**DESCRIPTION: Malcolm C. Hursey Montessori School at Ron McNair Campus
 Building No. 0734**

This addendum consists of the following attachments:

1.3 DRAWINGS

Project Number: 20076
Date: DECEMBER 17, 2021
Drawn By: KFS

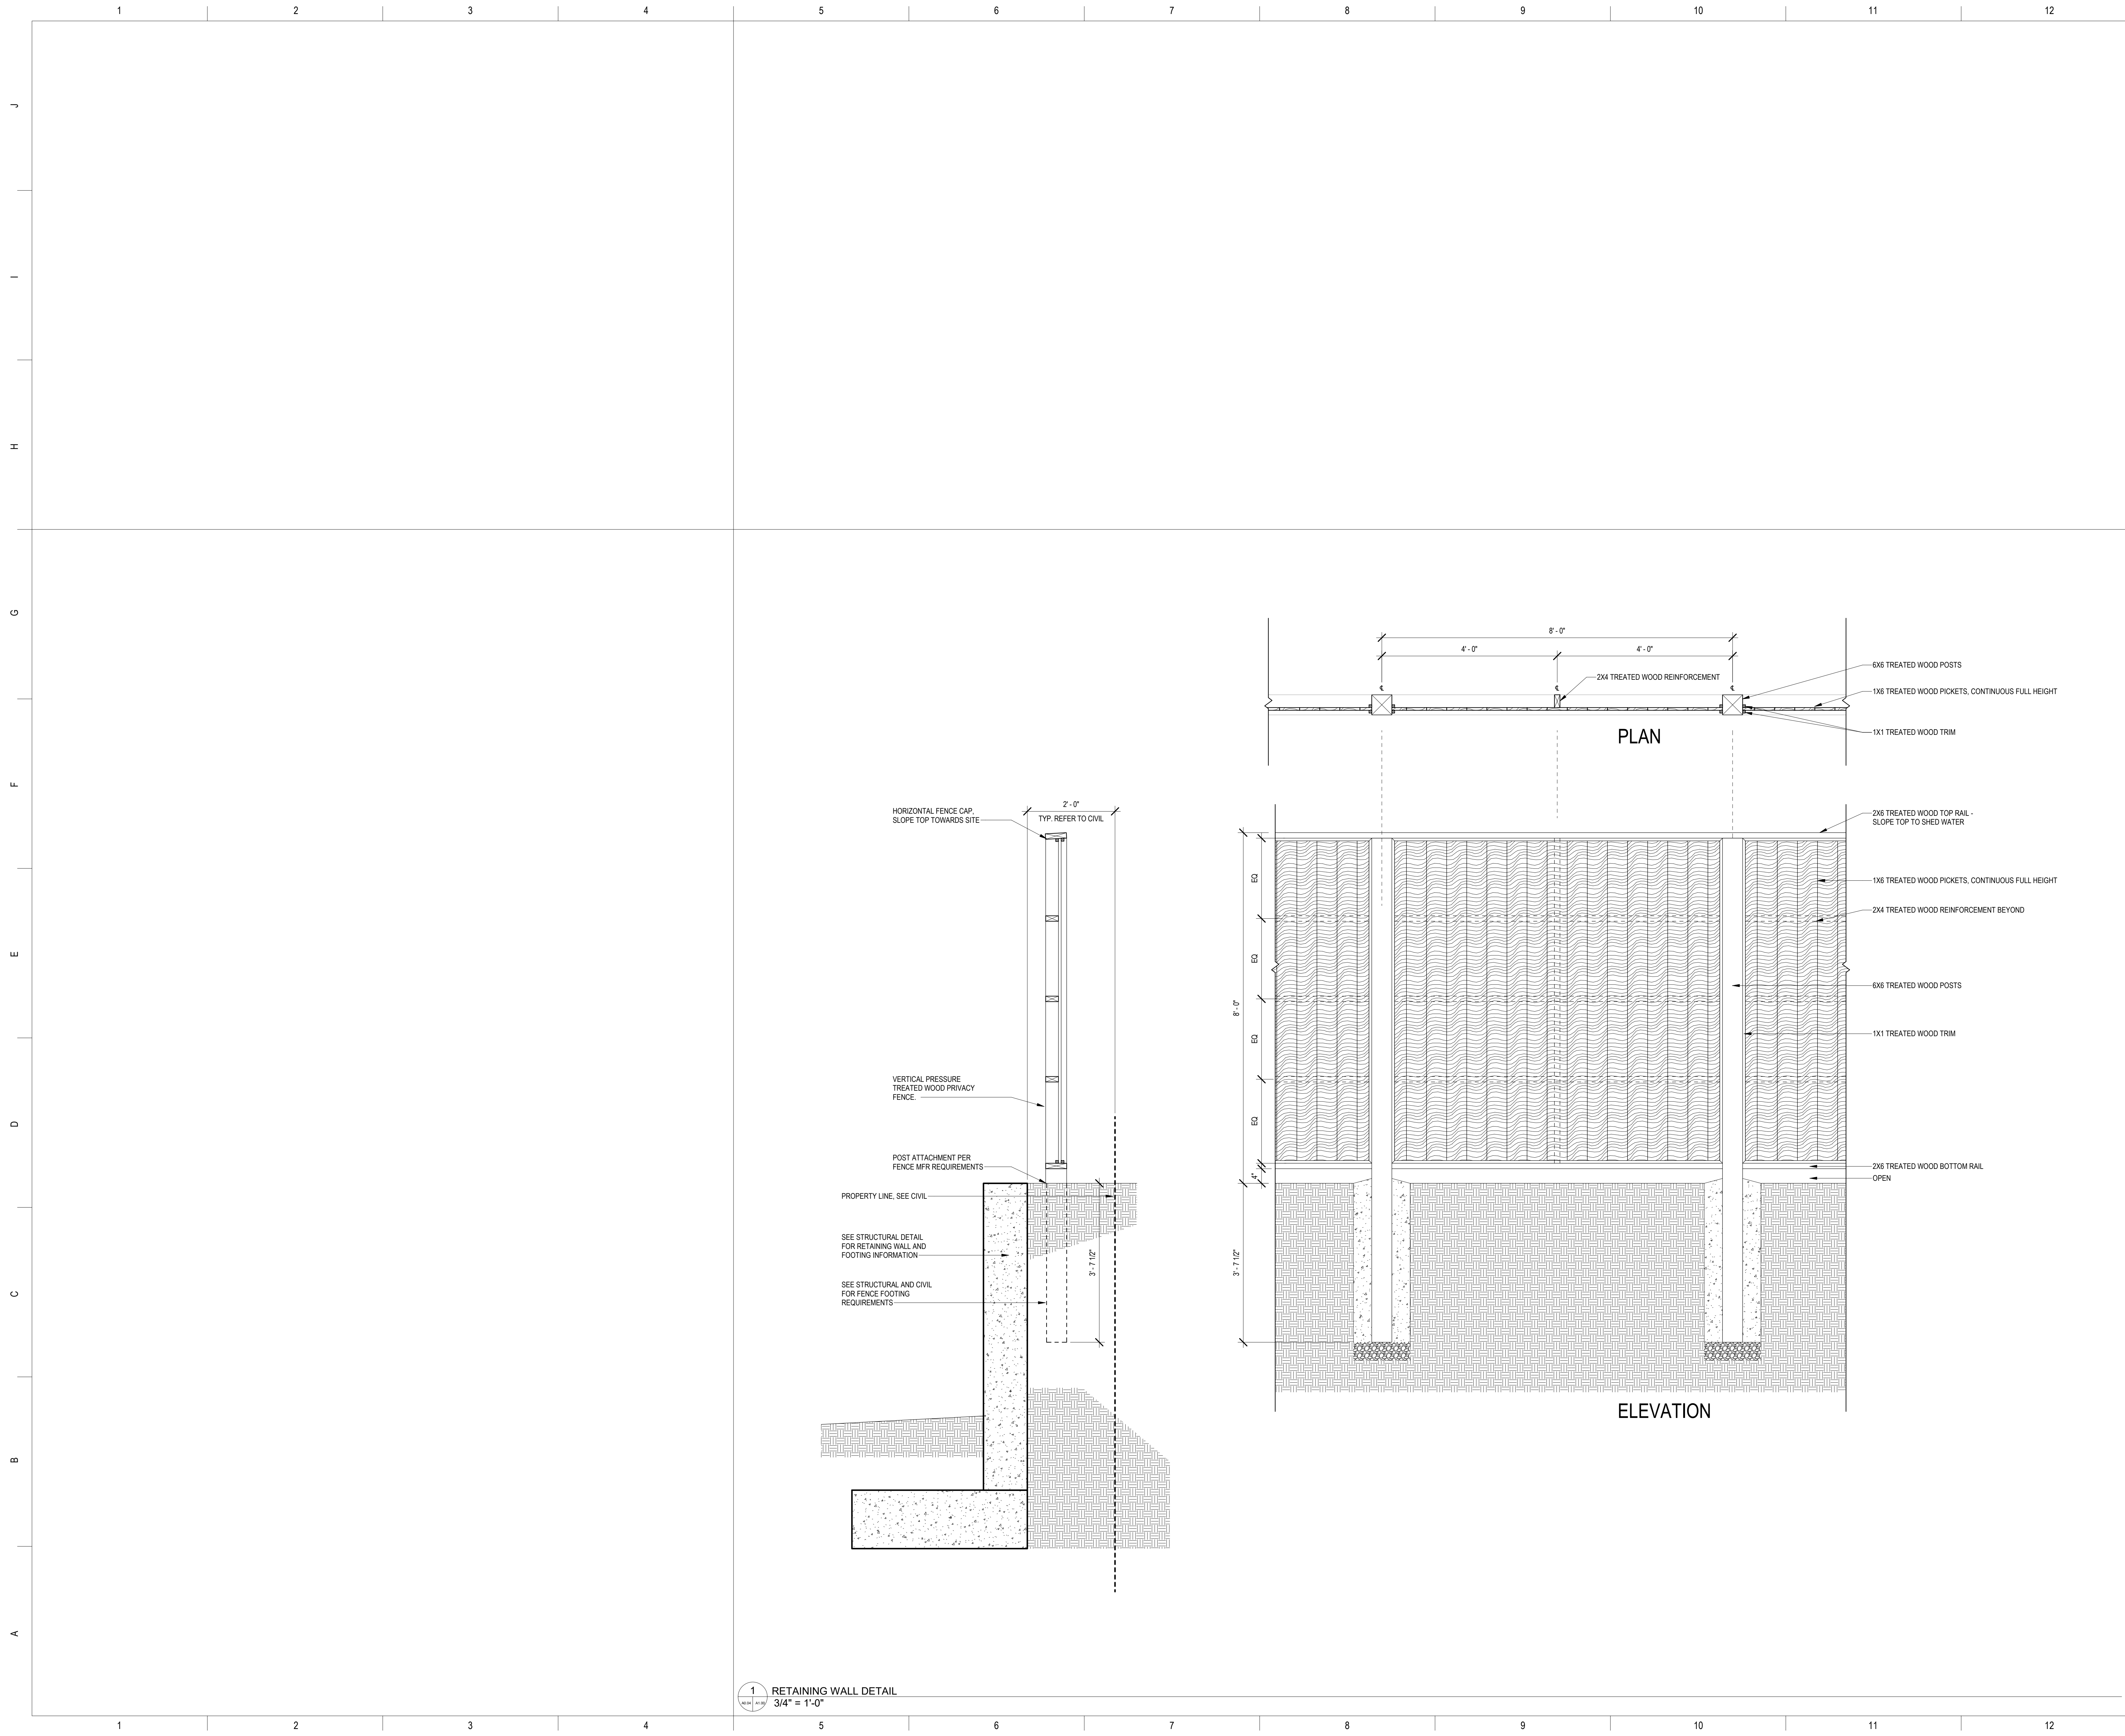
1. A0.03 SITE DETAILS
Updated wood privacy fencing detail
2. A0.04 SITE DETAILS
Added Sheet A0.04
3. A1.00 ARCHITECTURAL SITE PLAN
Revised wood privacy fencing, added detail references to the dumpster enclosure and garden shed.

S1.05

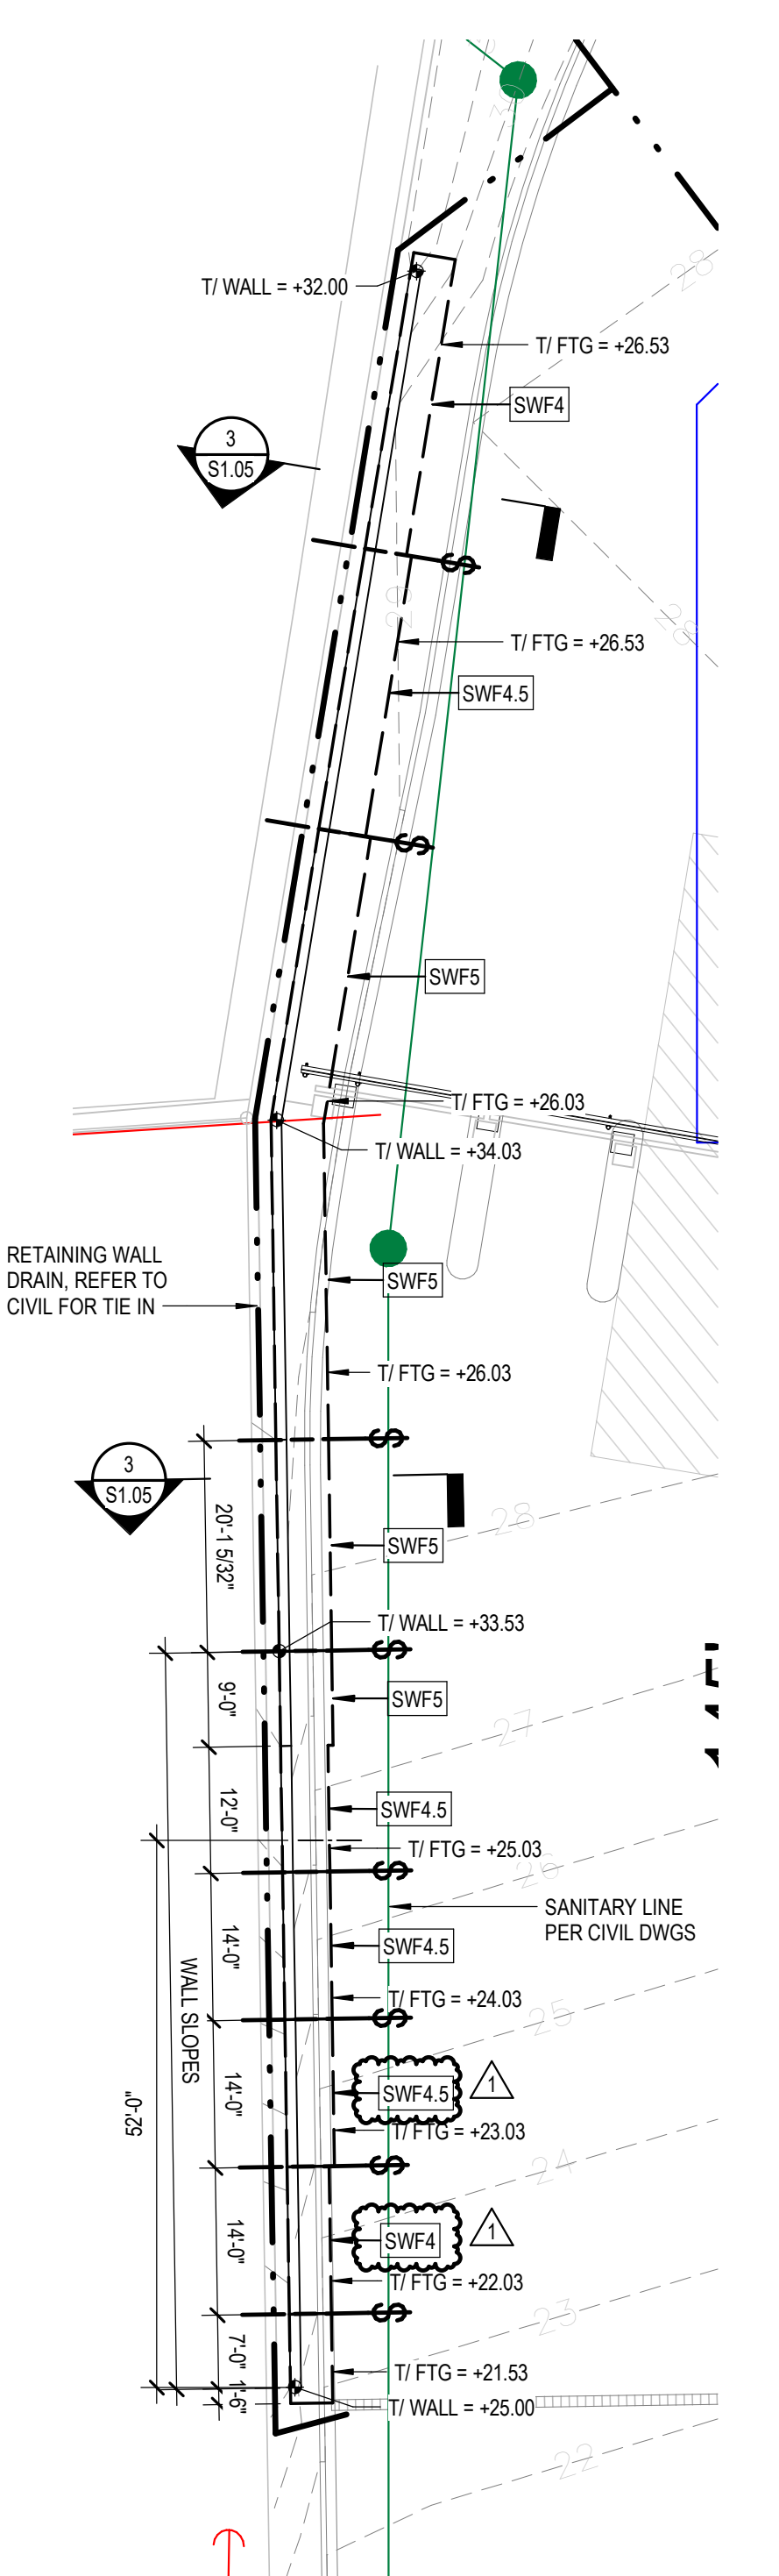
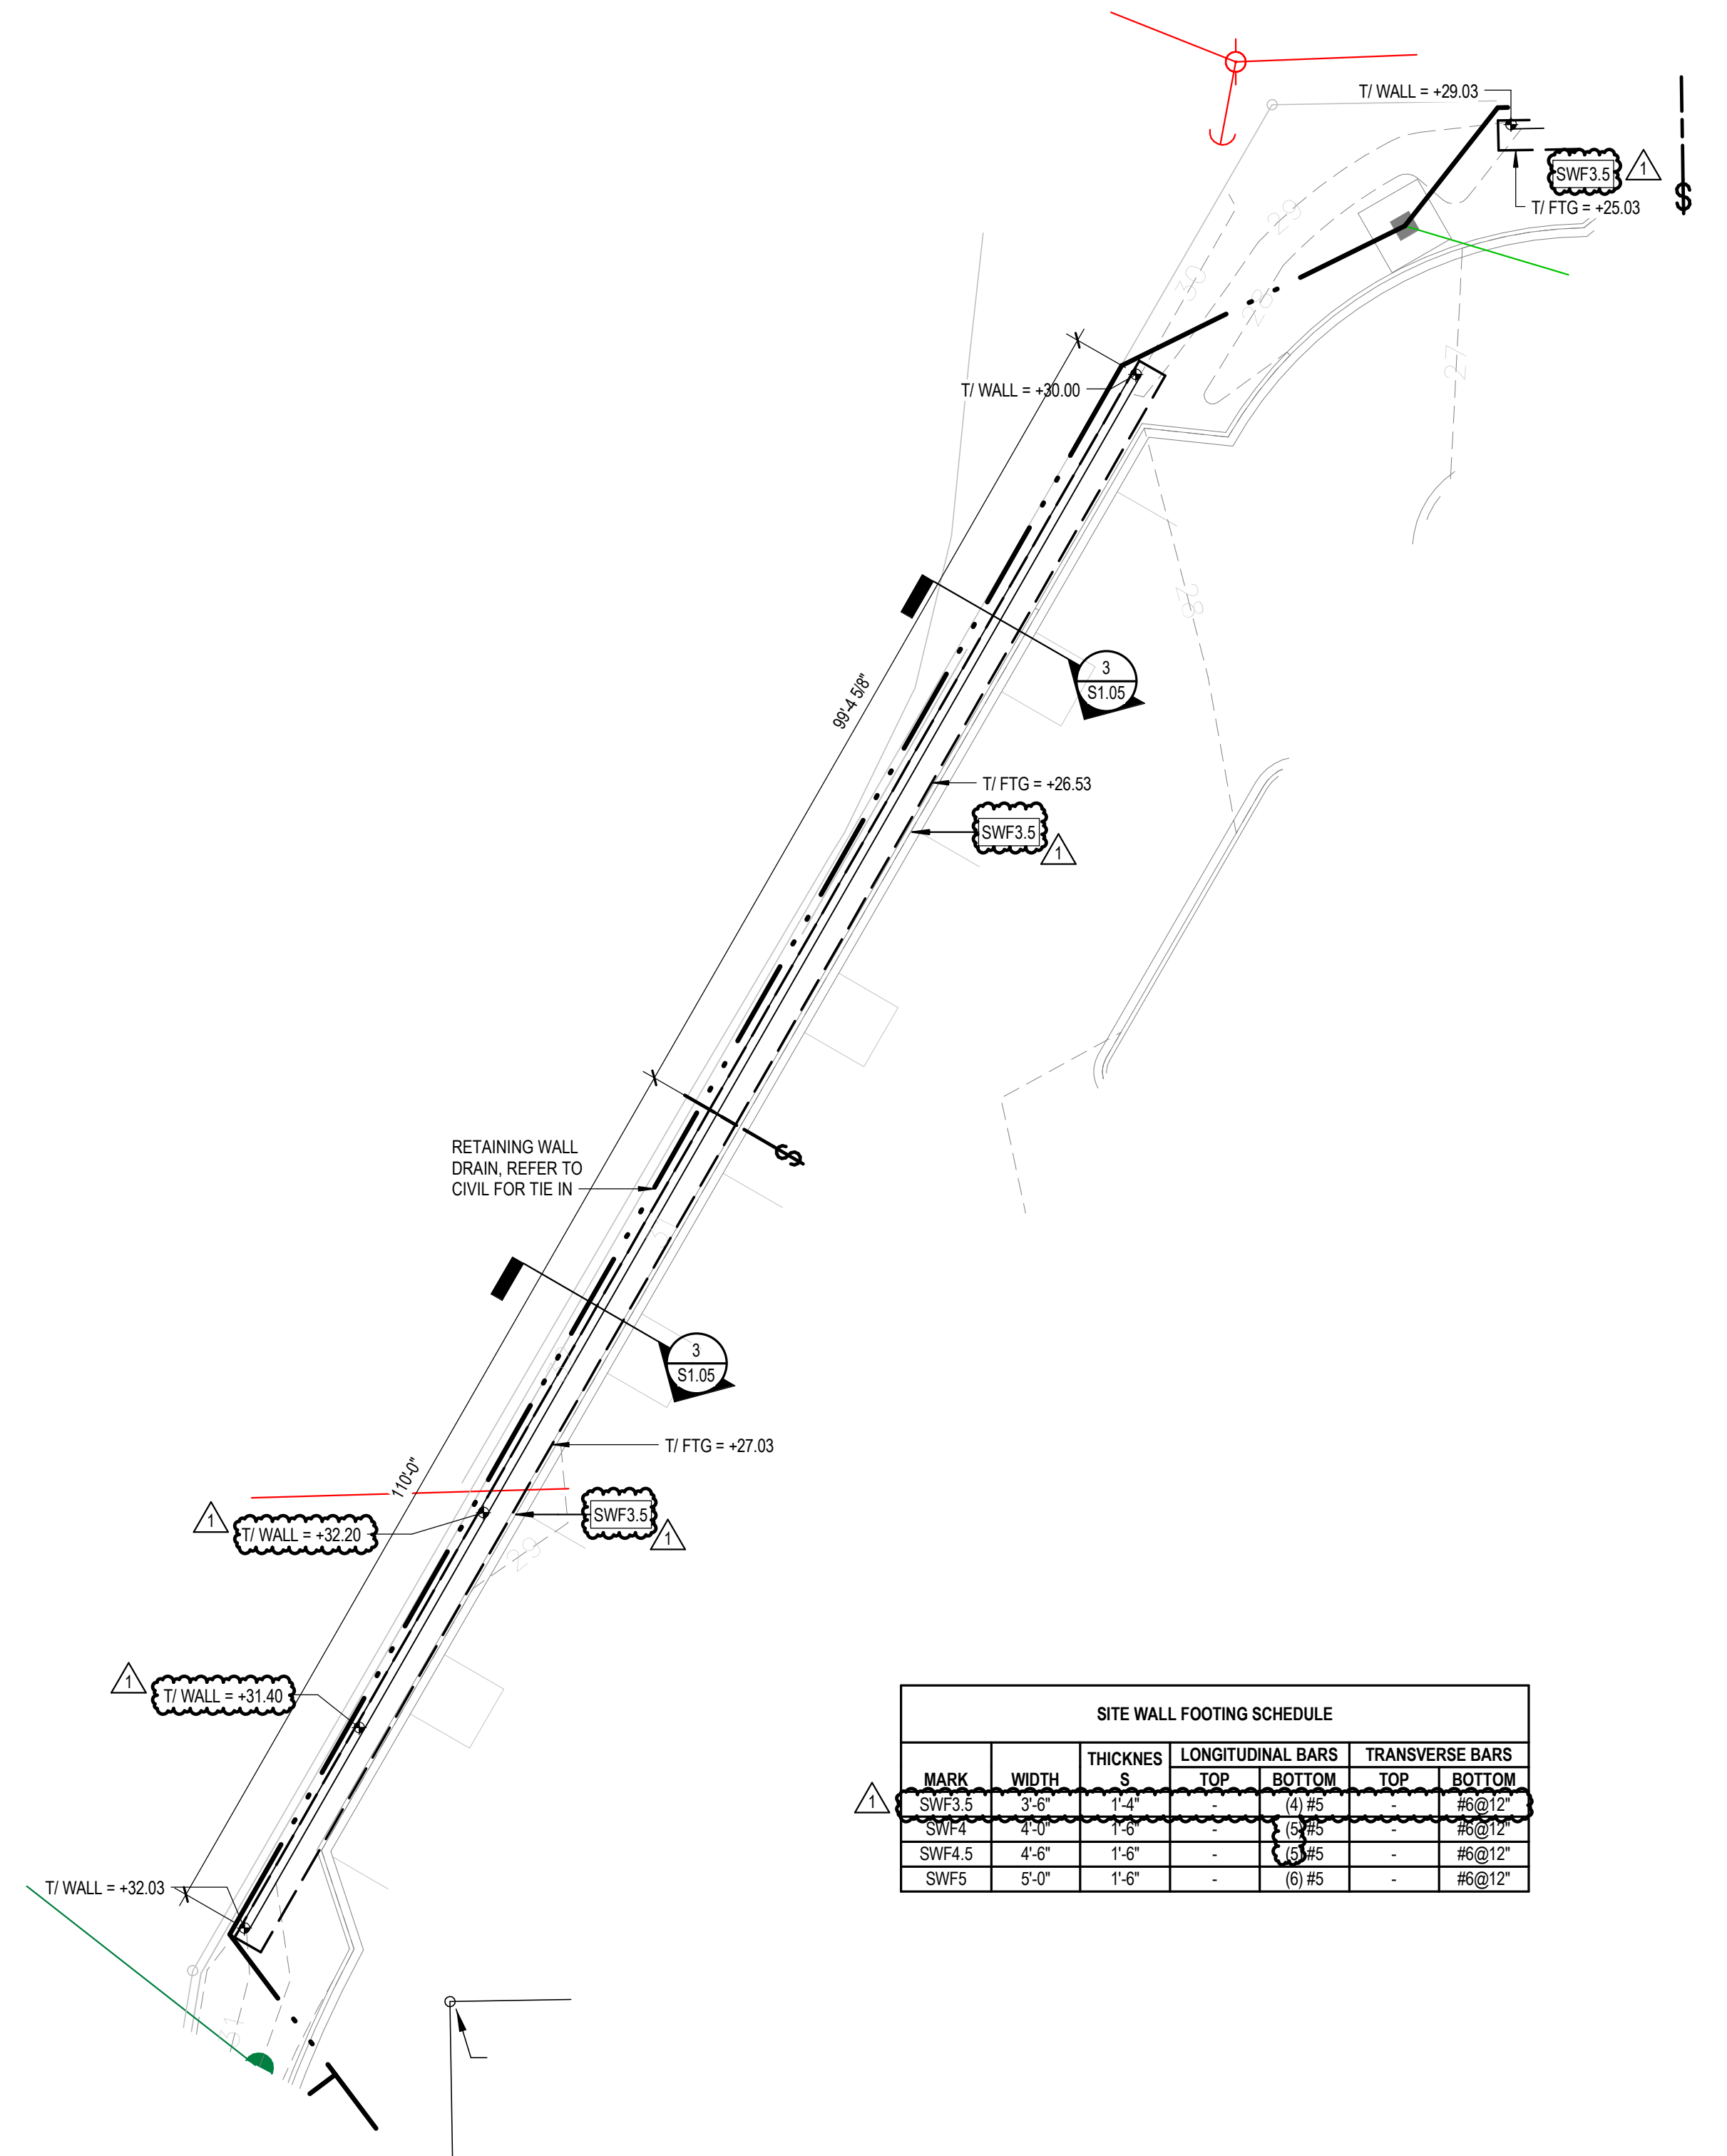
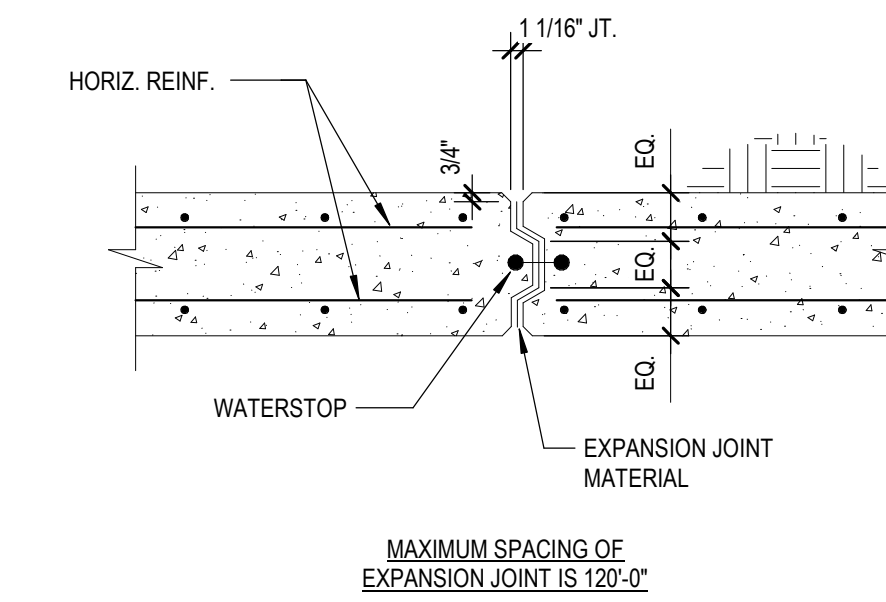
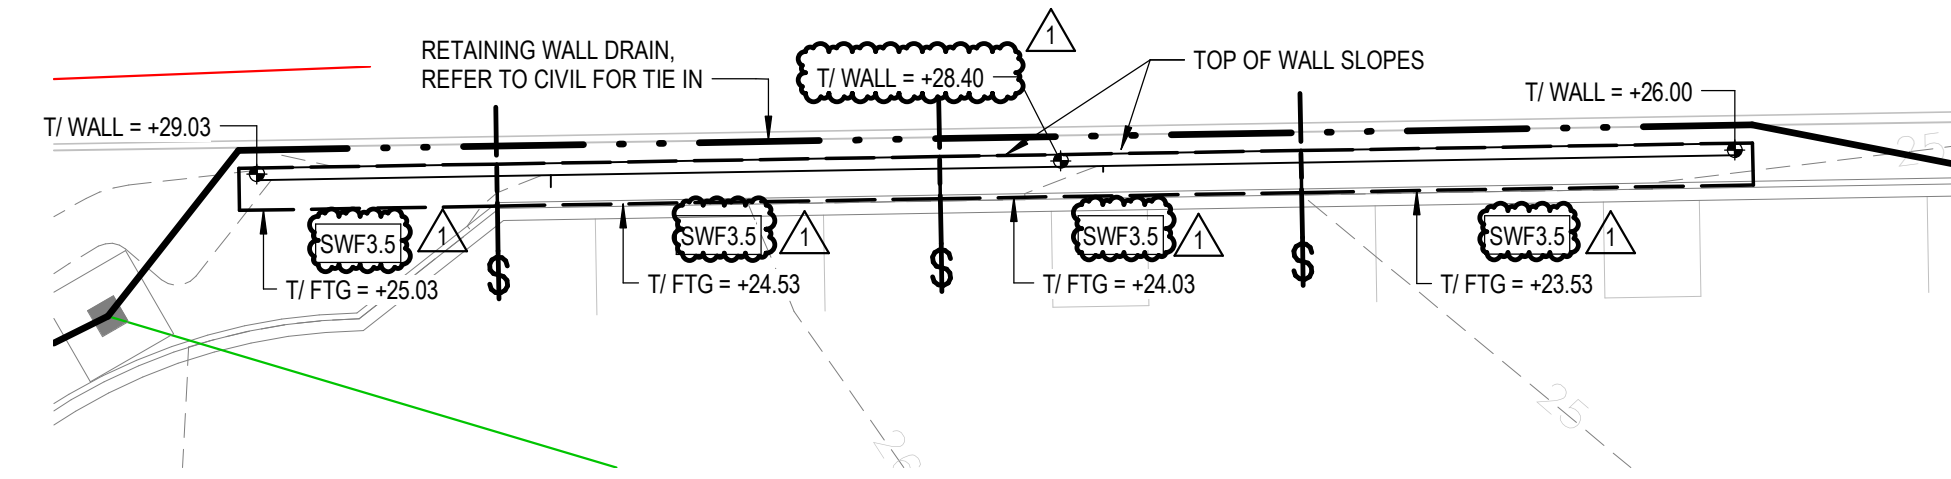
4. S1.05 SITE WALL PLANS
Revised top of wall elevations and footing sizes to match the latest civil drawings for parking variance.
